# **Mobile Pentium® II Processor Specification Update**

Release Date: March 1999

Order Number: 243887-008

Figure 2. Workaround Flowchart: SMBALERT#-Driven System

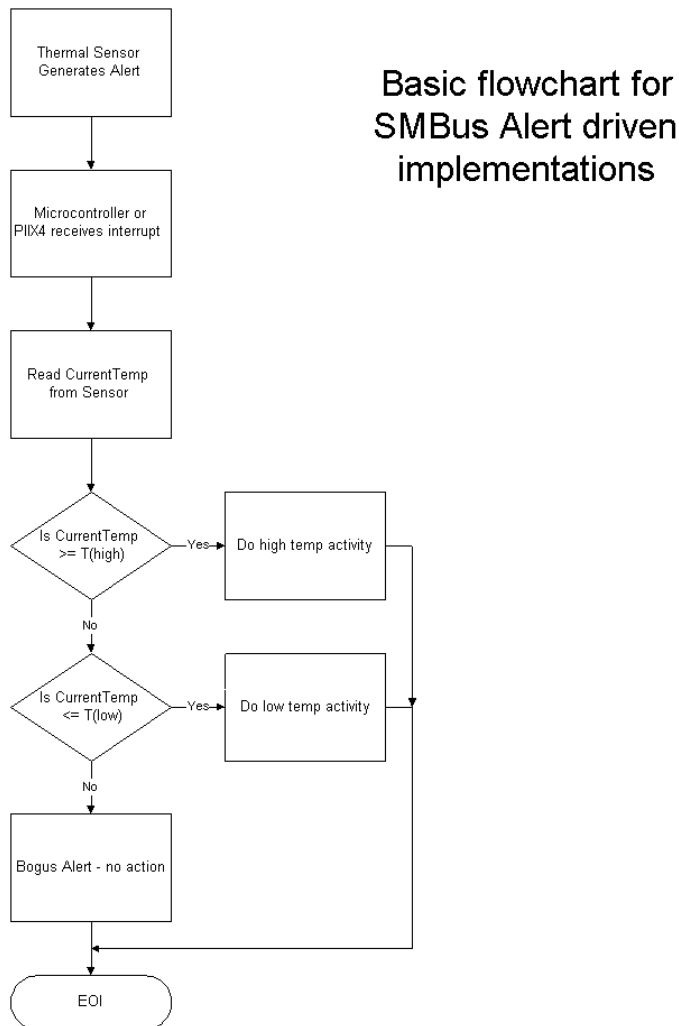
**WORKAROUND:** Three different (mutually exclusive) workarounds are possible:

1. Before servicing an interrupt from the thermal sensor, read and compare the processor thermal reading with the threshold limits ( $T_{HIGH}$  or  $T_{LOW}$ ). Figures 2 and 3 provide basic flowcharts for the implementation of this workaround in an interrupt driven system.
2. If the firmware implemented polls the Status Register only, then before taking any action, re-read the temperature register and do a comparison with the alarm threshold limits ( $T_{HIGH}$  or  $T_{LOW}$ ) to determine if the value is actually still within the temperature window.
3. Use a temperature polling scheme to monitor the processor temperature.

**Figure 5.6. Cross Sectional View with Vertical Dimensions**

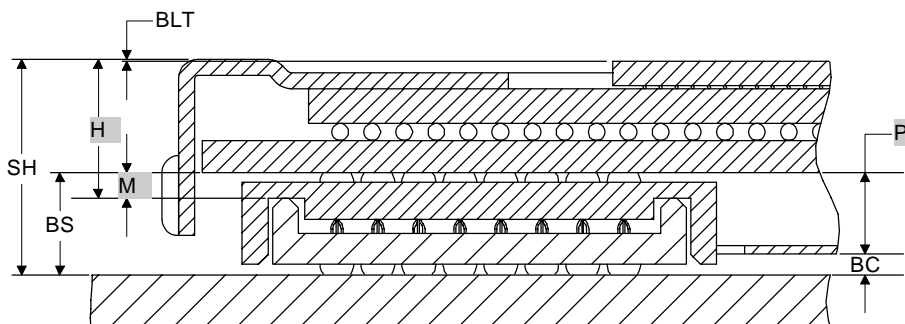
## B2. Misabeled Vertical Dimension Parameters

Figure 5.6 in the *Mobile Pentium® II Processor at 233 MHz, 266 MHz, and 300 MHz* datasheet should be replaced by the following figure:

Figure 1. TAP Gageable Thread Clarification

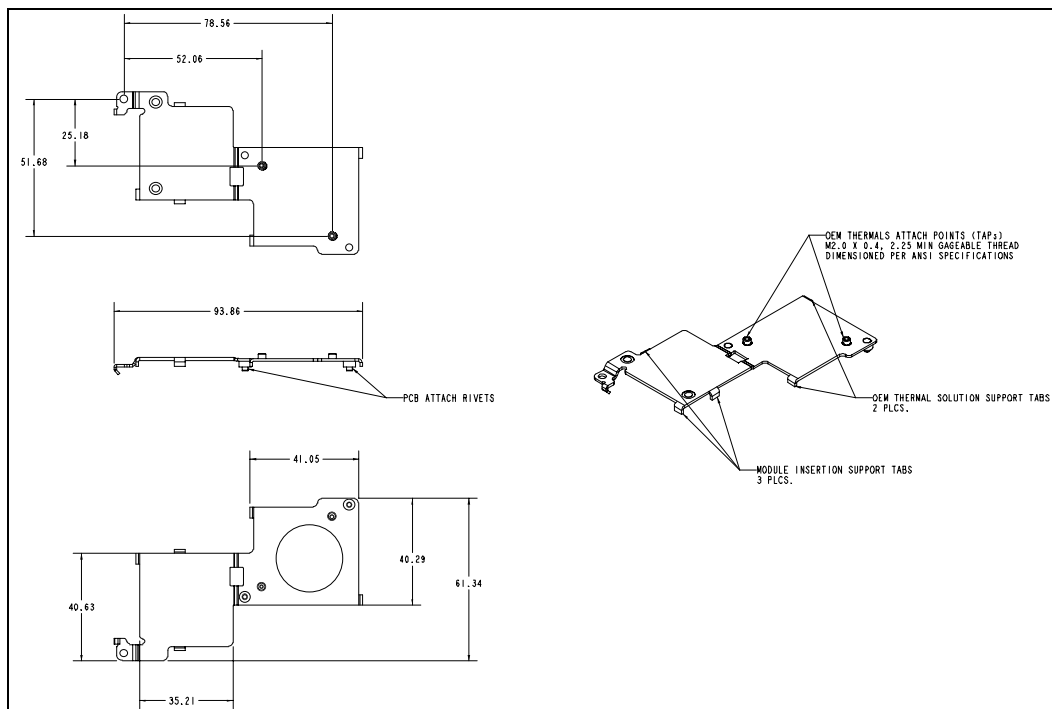
In the *Intel® Pentium® II Processor Mobile Module : Mobile Module Connector 1 (MMC-1)* and *Intel® Pentium® II Processor Mobile Module : Mobile Module Connector 2 (MMC-2)* datasheets (Order Numbers 243667 and 243668 respectively), the thermal attach point (TAP) gageable thread specification was not clearly identified in Figure 14, of Section 5.2. The following is the TAP clarification:

See Figure 1 below for more information.

OEM Thermal Attach Points (TAPs) M2.0 x 0.4, 2.25 min gageable thread dimensioned per ANSI specification.
